**Re: Lot 13 Block 6 Volcano Cliffs Unit 5
8015 Victoria Dr. NW
Grading & Drainage Plan
Engineer's Stamp dated: 11-20-19 (E10D038)**

DRAINAGE AND TRANSPORTATION INFORMATION SHEET (REV 6/2018)

**Lots 13, Block 6
Volcano Cliffs Subdivision, Unit 5
GRADING PLAN**

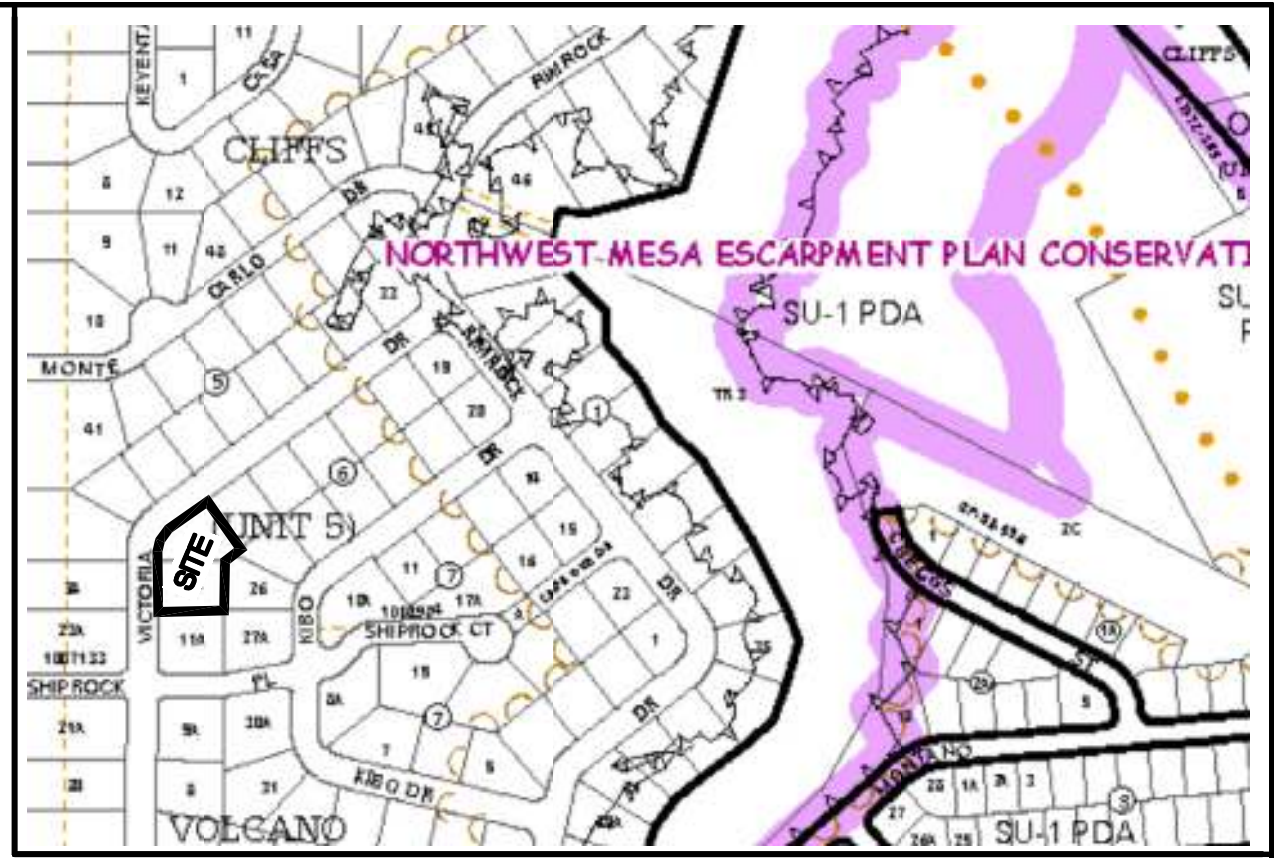
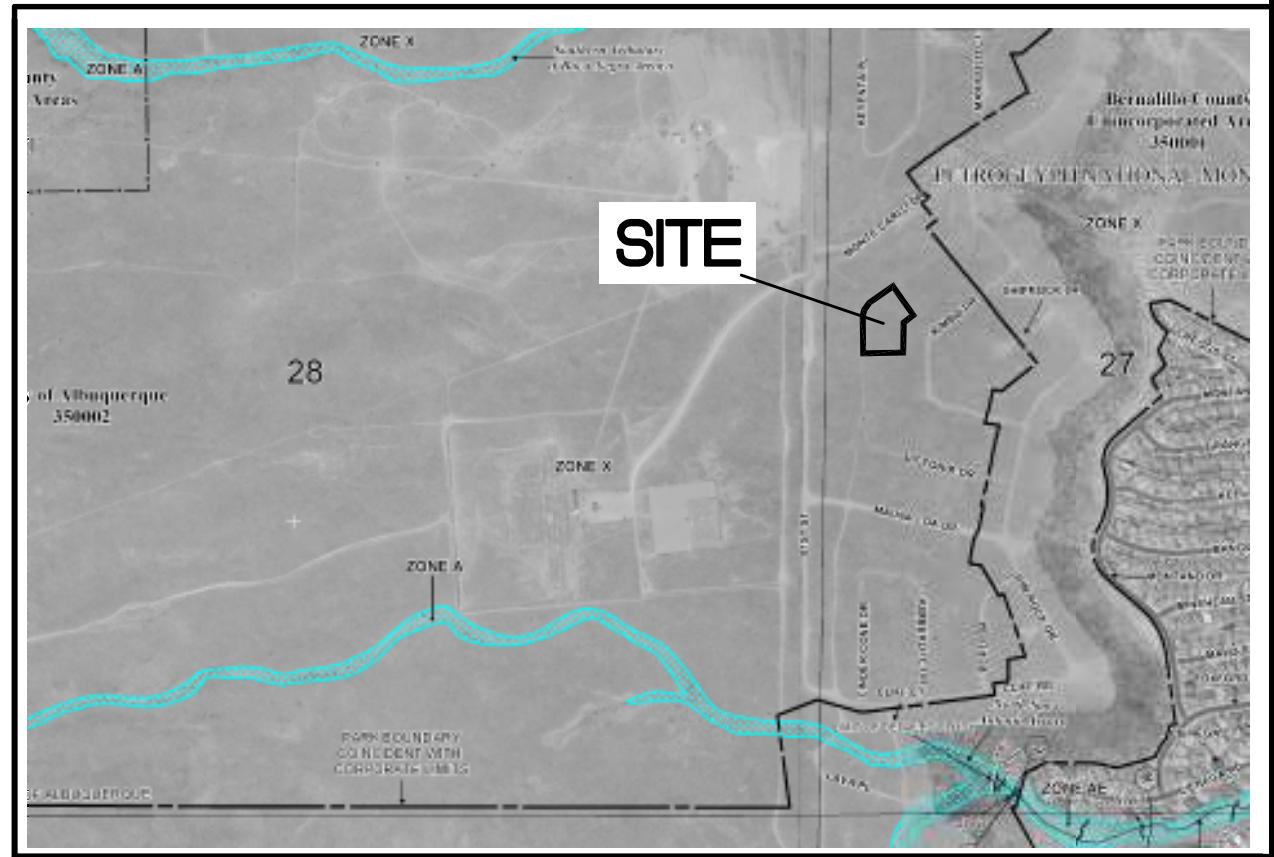
Based upon the information provided in your submittal received 1/22/20, this plan is approved for Building Permit. **Inform the owner/contractor not to use dirt as a ramp to climb the curb, wood or millings may be used for this operation.**

Reiterate to the Owner/Contractor that a separate permit for a garden/retaining wall must be obtained, with the approved G&D plan dated 11/20/20.

Prior to Certificate of Occupancy release, Engineer Certification per the DPM checklist will be required.
